WLPP-2003.5 **PAGE 3**
15-17 Lamrock Avenue, Bondi Beach - Demolition of two detached dwellings and construction of a four-storey boarding house and integrated car parking (DA-170/2019)

Report to the Waverley Local Planning Panel

Application number	DA-170/2019
Site address	15-17 Lamrock Avenue, Bondi Beach
Proposal	Demolition of two detached dwellings and construction of a four-storey boarding house and integrated carparking.
Date of lodgement	29 May 2019 (amended on 8 October 2019)
Owner	STM123 No. 9 Pty Ltd
Applicant	STM123 No. 9 Pty Ltd
Submissions	Original scheme: 61 submissions from individual properties and one petition including 245 signatories Amended scheme: 29 submissions from individual properties.
Cost of works	\$5,052,181
Issues	Character compatibility; car parking; non-compliance with height of buildings development standard; external wall height; overshadowing and privacy; operational aspects.
Recommendation	That the application be APPROVED subject to conditions of consent.

Figure 8: Extract of 3D Model of the height plane and area of where the development exceeds the height of buildings development standard (Source: Mark Shapiro Architects)

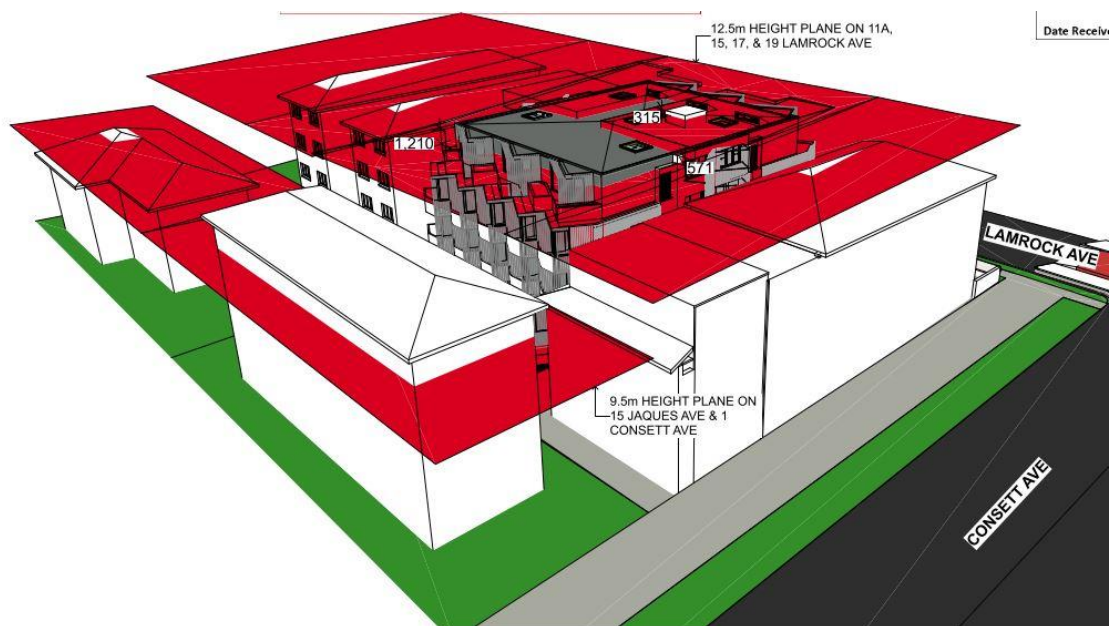
The site is subject to a maximum building height development standard of 12.5m. The proposed development has an overall building height of 12.714m exceeding the standard by 1.214m or equating to a 9.7% variation.

Figure 8 below is a visualisation of the extent and specific location of where the proposed development exceeds the height of buildings development standard.

- (iii) The non-compliance occurs within the rear portion of the development (as shown in **Figure 8**) and its extent is considered minor and inconsequential. The environmental amenity of neighbouring properties is preserved as the non-compliance will not manifest in adverse impacts on solar access, visual and acoustic privacy, visual bulk, views and

For the reasons provided above the requested variation to the height of buildings development standard is supported as the applicant's written request has adequately addressed the matters required to be addressed by cl 4.6 of the Waverley Local Environmental Plan 2012 and the proposed development would be in the public interest because it is consistent with the objectives of height of buildings development standard and the R3 Medium Density Residential zone.
